Proposal of Supplement 2 to the 06 series of amendments to UN Regulation No. 22 (Protective helmets)

The integration to the current text of the working document ECE/TRANS/WP.29/GRSP/2021/15 to complete the document and confirm limit value are marked in bold for new or strikethrough for deleted characters.

Annex 8 - New figure 1d, amend to read:

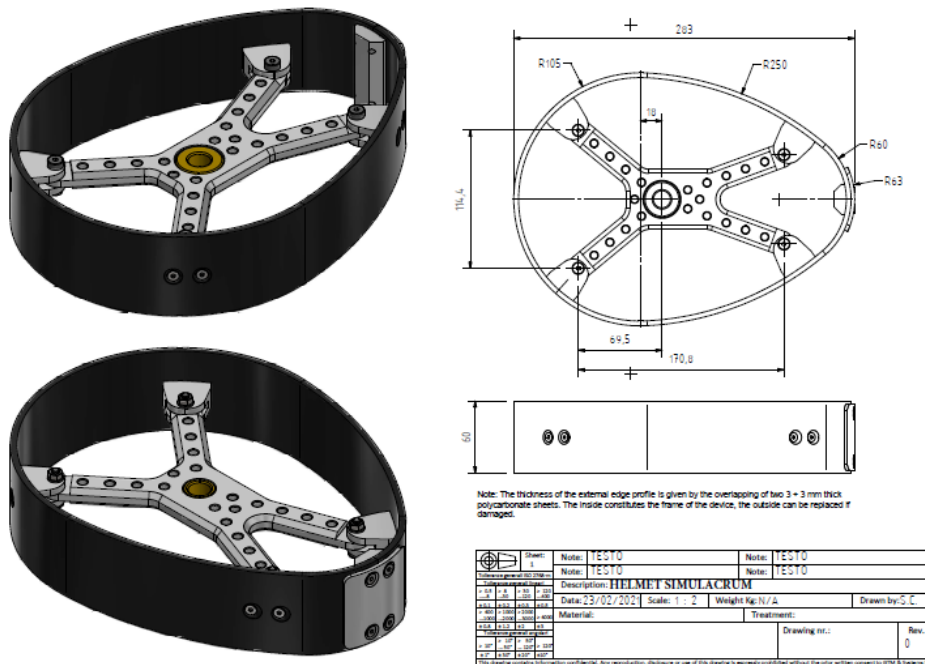
Example of a helmet simulator for accessories projections and surface friction (method B)

Figure 1

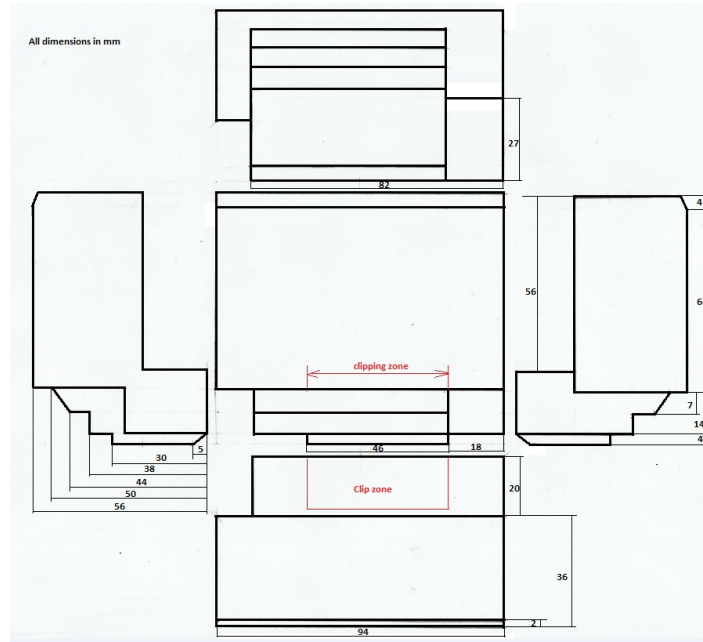
Fixture for left front- side mounting (for right side mounting apply symmetry)

VOLUME: 279,432 mm³

Figure 2

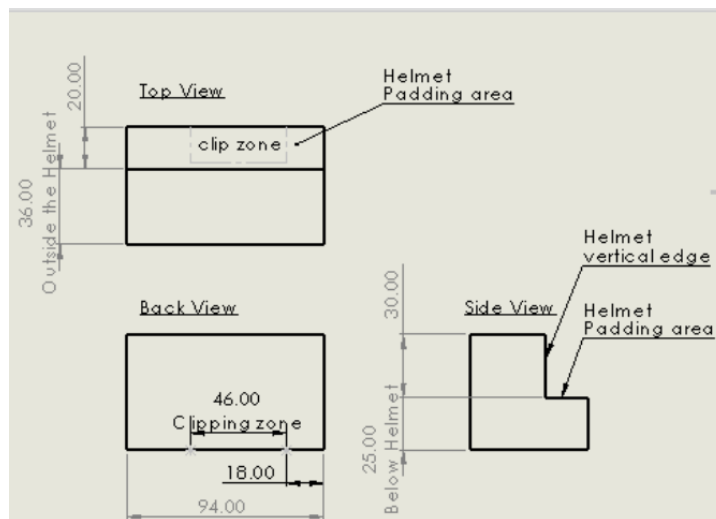
Fixture for left side mounting (for right side mounting apply symmetry)

VOLUME: 233,120 mm³

Figure 3

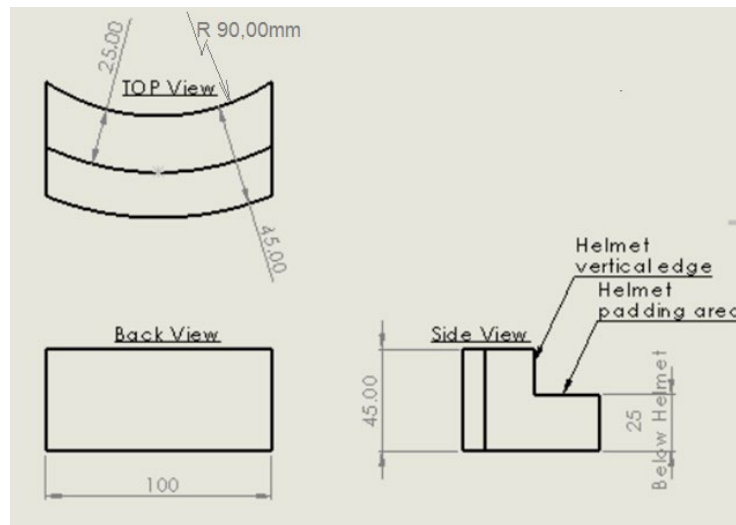
The rear mounting clamping solution offered by the accessories manufacturers will not invade the impact affected area.

VOLUME: $157,957\ \text{mm}^3$

2.2 Microphone

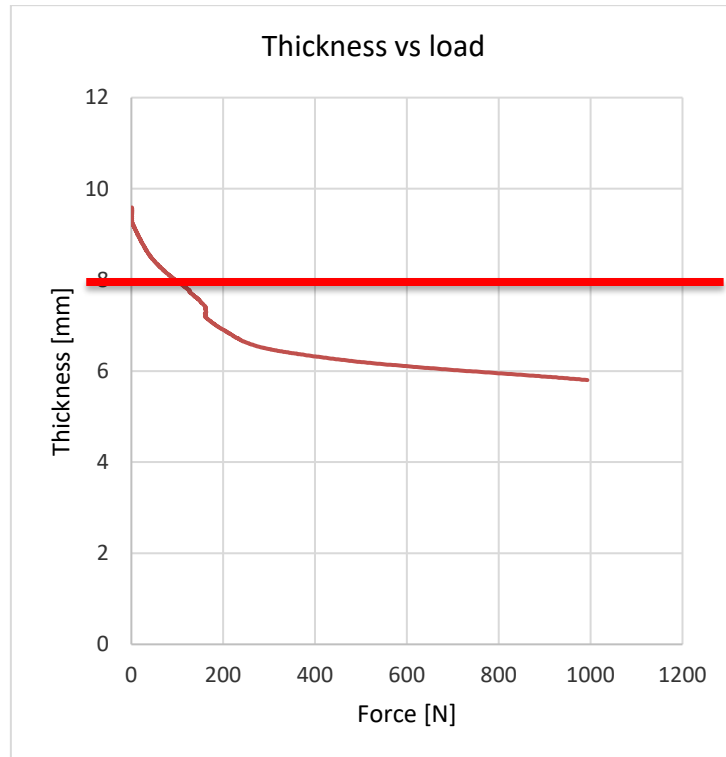
The microphone must be contained in a parallelepiped of the following dimensions:

Length: 35 mm

Width: 18 mm

Height (dimension from the chin protective padding towards the headform): 11,5 mm

The boom, if any, must be flexible and not have an external diameter of more than **8 mm**

Part 2. Clamping space dimensions for helmets (OPTIONAL)

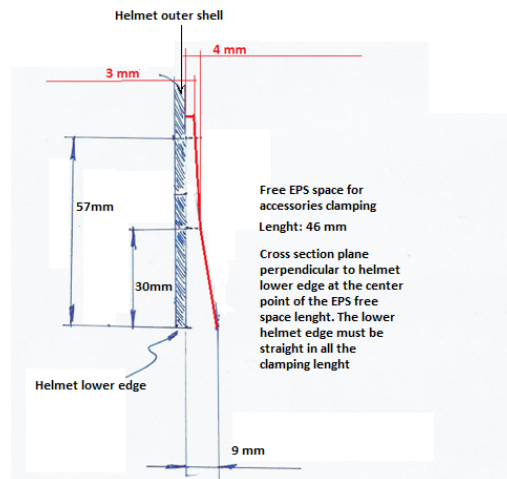
1. The helmet clamping free space dimensions for front and side mounting will be, at least, the following ones
- 2.

Length of clamping according to the fixture drawings

3. Helmet clamping free space dimensions for rear mounting

The helmet must allow the insertion of a flat metal sheet of **1 mm** thickness, as one of the possible fixation systems for rear positioning of the accessories, between the EPS and the external shell.
